Access Compliance Report Public Rights-of-Way (Curb Ramps)

Main Street: TREASURE_LN		Cross Street: ARROYO_AVE		Location:	S
ADA ID: RPRK220125140822	Ramp Type: Type 1 - Perpendicular Diagonal Initial Pass/Fail: Fail		Overall Compliance: No	Severity Score:	60

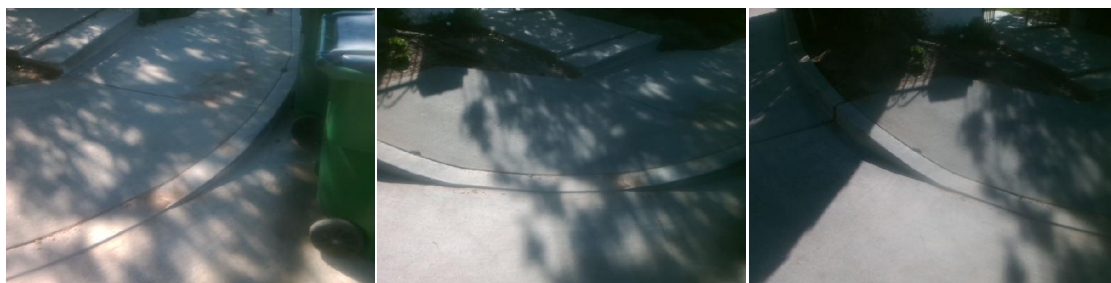
Compliance	Description	Data	Compliance	Description	Data
N/A	Ramp Length (in)	59	N/A	Flare Type LT	
Yes	Ramp Width (in)	48			N/A
No	Ramp Run Slope (%)	13.8	N/A	Flare Slope LT (%)	N/A
No	Ramp Cross Slope (%)	11.5	N/A	Flare Traversable LT	N/A
N/A	Landing Present	N/A	N/A	Flare Type RT	
N/A	Landing Length (in)	N/A			N/A
N/A	Landing Width (in)	N/A	N/A	Flare Slope RT (%)	N/A
N/A	Landing Run Slope (%)	N/A	N/A	Flare Traversable RT	N/A
N/A	Landing Cross Slope (%)	N/A	N/A	DWS Provided	N/A
N/A	Landing Movement Obstructed?	N/A	N/A	DWS Contrast	N/A
	Landing Movement Type	N/A	N/A	DWS Length (in)	N/A
N/A	Landing Shared	N/A	N/A	DWS Full Width	N/A
N/A	Clear Space	Yes	N/A	DWS Offset Left (in)	N/A
N/A	Clear Space To Crosswalk (in)	N/A	N/A	DWS Offset Right (in)	N/A
N/A	Marked Crosswalk 1	No	N/A	Marked Crosswalk 2	No
	Crossing 1 Direction	NE		Crossing 2 Direction	NW
	Marked Crosswalk 1 Width (in)	N/A		Marked Crosswalk 2 Width (in)	N/A

N/A	Ramp Inside Crosswalk 1	N/A	Yes	Ramp Inside Crosswalk 2	N/A
	Crossing 1 Slope (%)	7.2		Crossing 2 Slope (%)	4.6
	Crossing 1 Cross Slope (%)	10.6		Crossing 2 Cross Slope (%)	4.3
N/A	Gutter Ponding	N/A	N/A	Curb Slope	2.4
No	Gutter Lip Height (in)	0.25		Road Run Slope (%)	7.9
N/A	Gutter Run Slope (%)	N/A		Road Cross Slope (%)	3.6
N/A	Gutter Cross Slope (%)	N/A			
Yes	Overall Surface Condition: Acceptable		No	Perp Joint Present	No
	Cross Gutter Present?	Yes		Spandrel Present?	Yes
	Replace Cross Gutter?	No		Replace Spandrel?	No

Remove & Replace Curb Ramp With Two New Directional Ramps or Equivalent. Grind Gutter Lip.
